Staff Analysis

- Agenda Item: **4.B**
- Proposal: **Application for preliminary site plan approval for the Lake Point Lodge - an apartment building, club house and associated improvements on 5.02 acres, more or less.**

- Case No: PZ15-03
- Applicant: KGH Building Group LLC
- Owners: SKG, LLC
- Parcel # (s): 20-7.0-26-100-003-012.001, 20-7.0-26-100-003-012.002 and 20-7.0-26-100-003-013.000.

100 ft
50 m

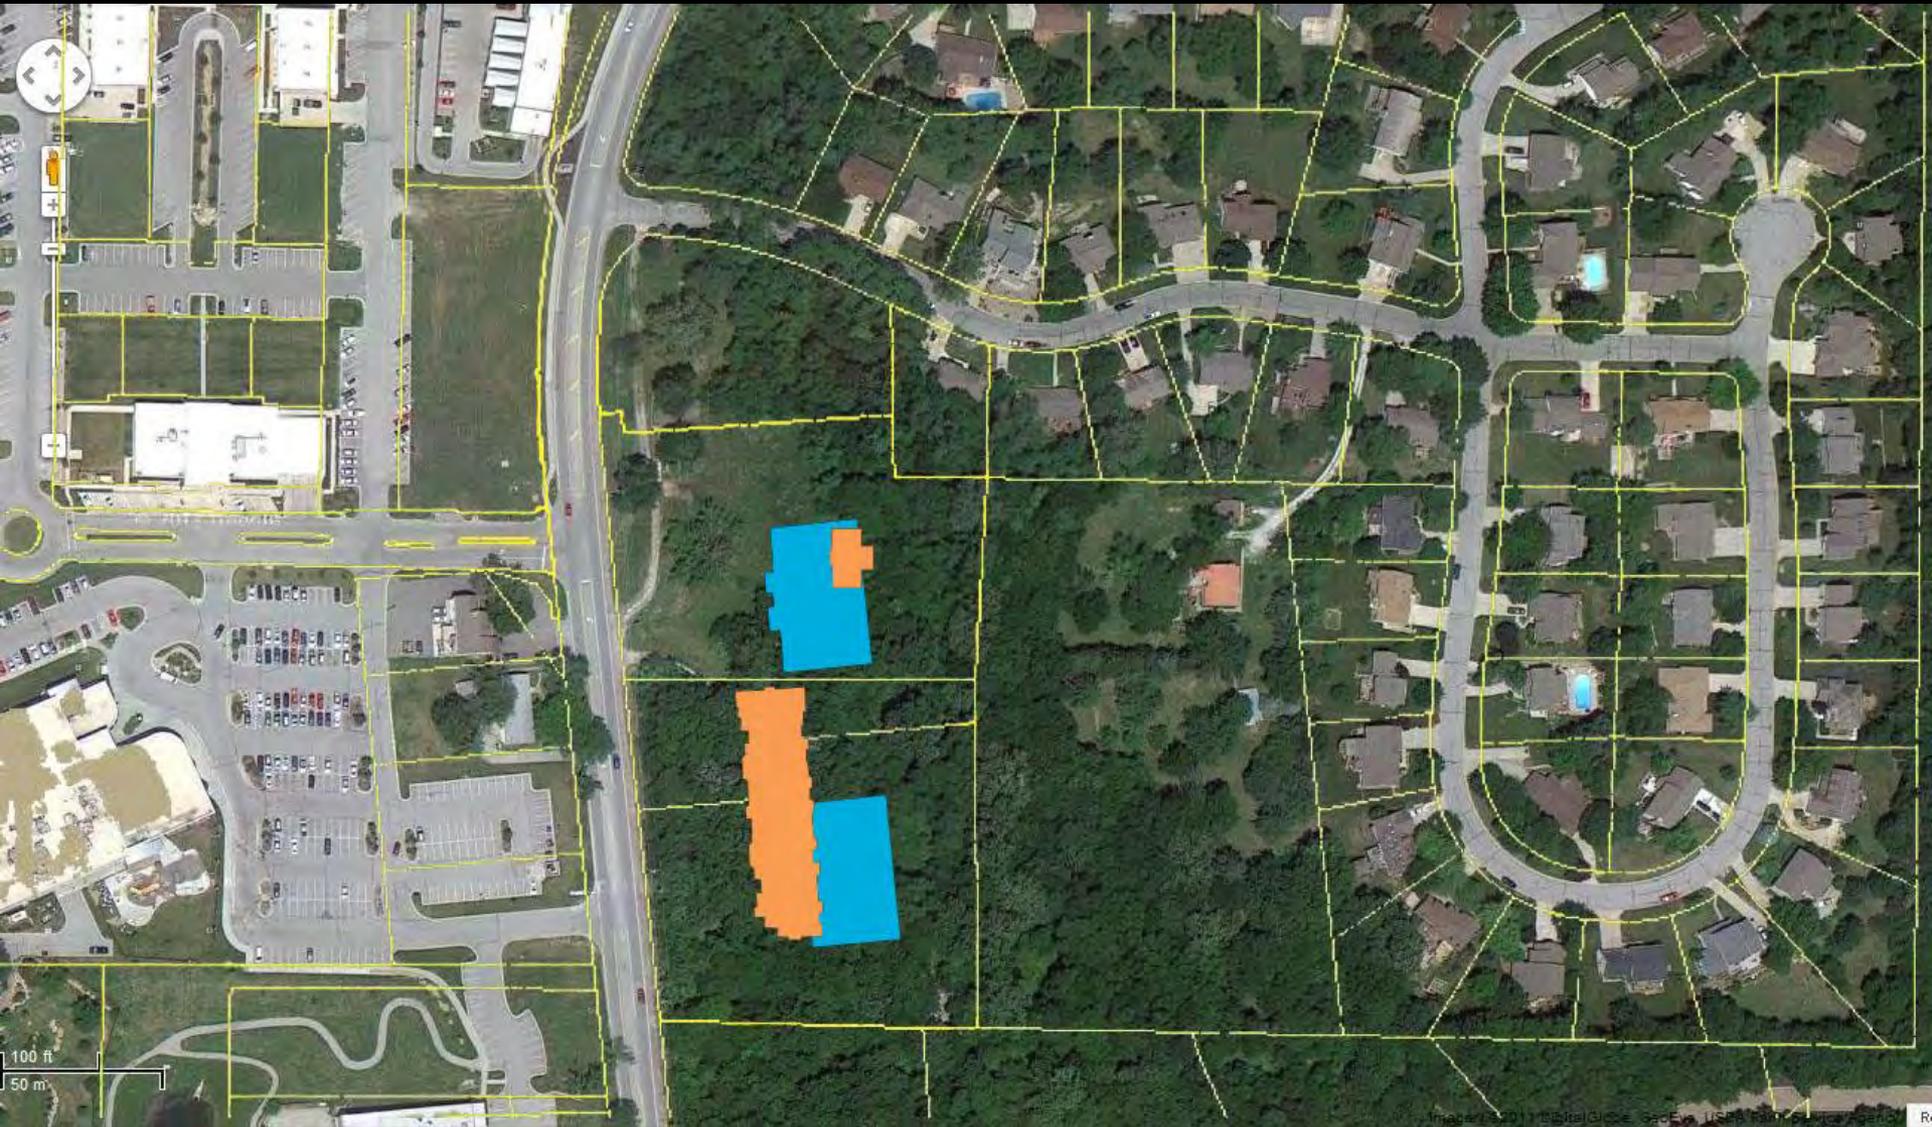
The applicant has also provided drawings comparing the previously approved site plan to the proposed site plan. The plans demonstrate that the proposed apartment building reduces the lot coverage, increases the open space and vegetation preserved, and has less massing than the previously approved office buildings. They also provide sample views from the nearest abutting residential property to the northeast and from 9 Highway (looking northeast toward the proposed building).
